Access Compliance Report

Public Rights-of-Way

(Curb Ramps)

Intersection ID: 17138	Main Street: IDLEWILD_RD	Cross Street: PINEY GROVE RD	Location: E
ADA ID: DDC9A710DFB8	Ramp Type: BlendTrans2	Initial Pass/Fail: Fail	Overall Compliance: No
Severity Score: 8.75			
Codes/Mitigation Info/Possible Solution		Field Measurements/Component Compliance

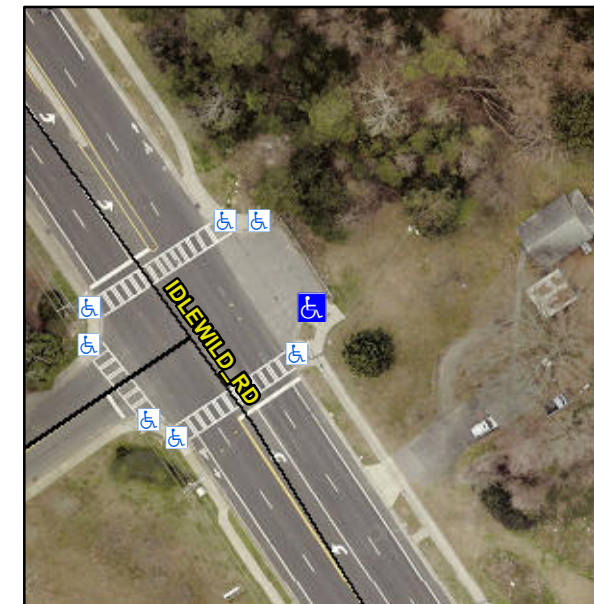
Remove & Replace Curb Ramp With Two New Directional Ramps or Equivalent.

Not Found, R304.5.1
